MEMORANDUM

SUBJECT: BZA Case 19173, 1264 Holbrook Terrace, N.E.

T. OFFICE OF PLANNING RECOMMENDATION

Previous Proposal

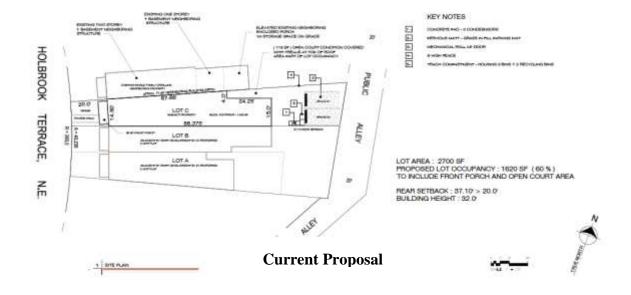
The applicant previously submitted plans depicting conversion of the existing single-family dwelling on the large 7,505 square feet lot into an eight-unit apartment structure, consistent with the unit per lot area requirement under Section 401. However after discussions with OP and the community the applicant revised the plans to adjust the design characteristic to a row house format rather than an apartment format.

OP initially expressed concern regarding the potential impact of windows along the south facing façade of the initial proposed addition. However, the applicant has substantially revised the proposal to reflect a row character rather than an apartment building.

The applicant has now submitted revised plans and now proposes to convert the existing singlefamily residential structure on a newly created lot of 2,700 square feet, identified as Lot C, to a 3unit residential building, with rear surface parking with 2 spaces. The renovation and conversion would consist of a single story addition above the existing two-stories and a rear three-story
